Design Review Committee September 15, 2021

Design Review (DRC No. 4898-17)

PROPOSED ADDITION & REMODEL FOR EXISTING AUTO REPAIR SERVICE
2640 N. SANTIAGO BLVD., ORANGE, CA 92867

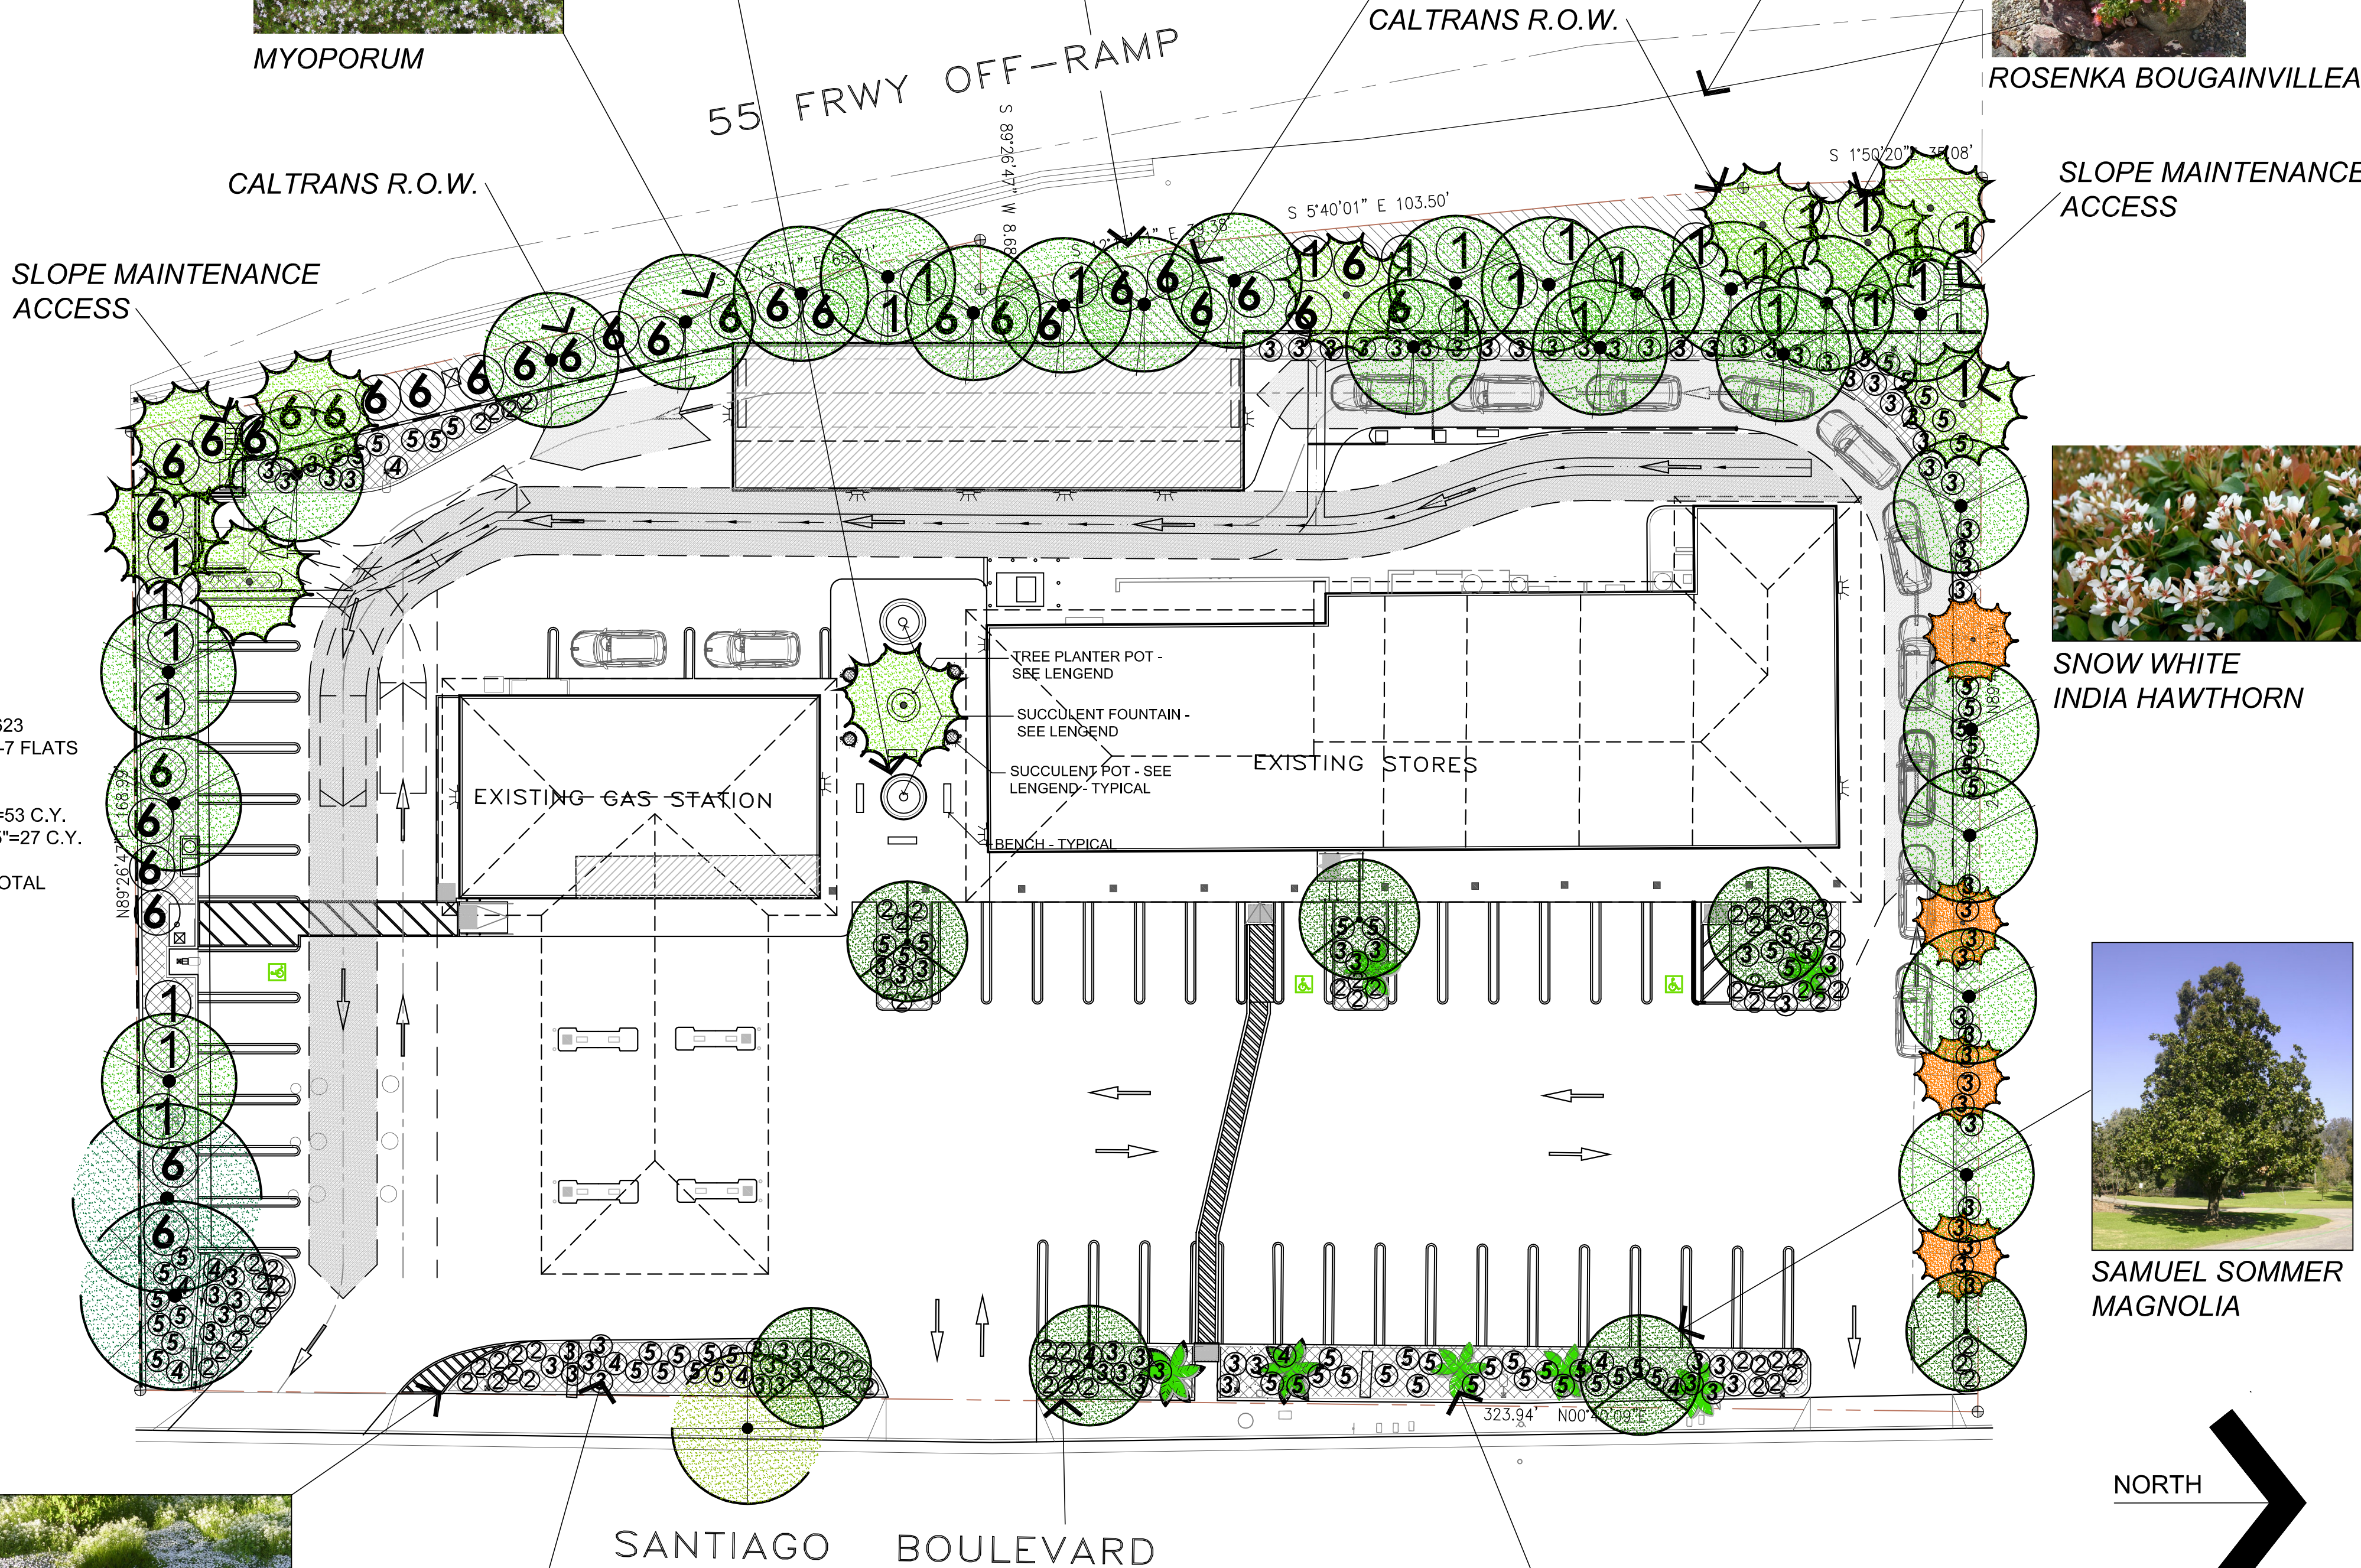
- The survivability of plants and delivery of irrigation on the 2:1 slope.
- Suggested fence access points along the top of the slope for landscape maintenance

- Suggested the elimination of Iceberg roses on the slope due to the high frequency of maintenance required and difficult access on the slope.
- The viability of trees proposed close to the car wash building given a 36-inch roof overhang.
- The amount of landscape and hardscape is grossly out of balance.
- The lack of landscaping west of the chain link fence.
- The lack of protection of the light poles in the landscape planters in the queueing lane because there are no curbs.
- The project does not reflect a clear understanding of the slope and does not address concerns that the Committee has had from the beginning.
- The overall feasibility of the project and inability to make findings if the Site Plan does not match the site conditions and if the mitigation that is being proposed is not achievable.

The Conceptual Landscape Plan (Sheet L1) has been adjusted to show the correct number of existing trees to remain, street tree, and proposed trees for the project. The plan has been modified to accurately show the proposed landscaping between the Caltrans easement chain link fencing and the retaining wall at the top of the rear slope. A dense grouping of Chinese Elm and Fern Pine trees are provided along the slope to address the mass of the new car wash building and rear view of the multi-tenant building, and between the convenience store and multi-tenant building. The Applicant has indicated that the plant material selected for the slope are varieties that can withstand harsh weather conditions. The proposed irrigation will be a drip system with emitters built into the tubing, spaced every 18-inches. The drip tubing will be pinned into the slope with metal stakes manufactured for this purpose and the tubing will be covered with 3 inches of mulch. The mulch will have fibrous bark that will cling to the slope. In addition, the applicant has adjusted the location of trees along the

slope so as to not impede on the car wash building roof overhang. Lastly, a six-inch curb has been added to the landscape planter along the queue lane for protection of the proposed pole light fixtures.
